Date: October 28, 2024
Project No.: 1539-1-1

Re: Geotechnical/Geologic Peer Review
226 Highway 1
Carmel, California

Introduction and Background

Feature A – A deposit of Qoal.

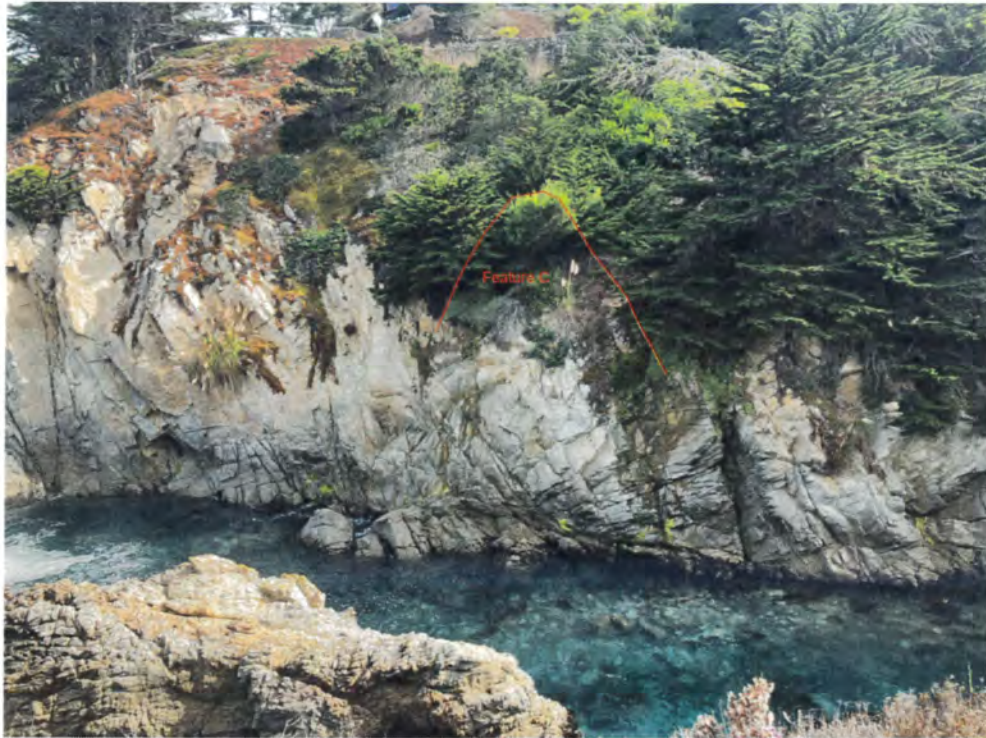
- a. A deposit of Qoal is located beneath the proposed autocourt and also downslope of the southeastern end of the proposed residence as shown on the Easton geologic map. This elongated deposit appears to occupy a sloping swale surface that steepens towards the face of the slope as shown in geologic cross-section D-D'. It would appear that this deposit might be a landslide. The unsupported toe of this deposit is shown as Feature "A" in the attached photo.
